Product/Process Change Notifications

PCN - 26 112

PCN for HVDC 125 – Product Label Change and Drawing Note Updates

Product : PCN for HVDC 125 – Product Label Change and Drawing Note Updates

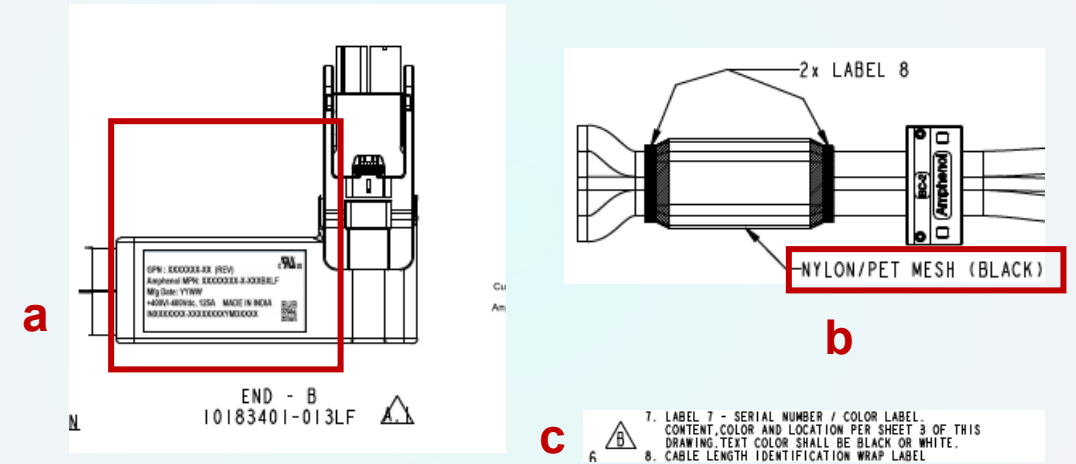
BEFORE

AFTER

- a) The product label has been changed from a wrap-around label to an adhesive label applied to the End B connector over-mold.
- b) PET has been added together with the nylon mesh.
- c) The serial number label has been updated to allow the text color to be either black or white, provided the text remains clearly legible on the label.
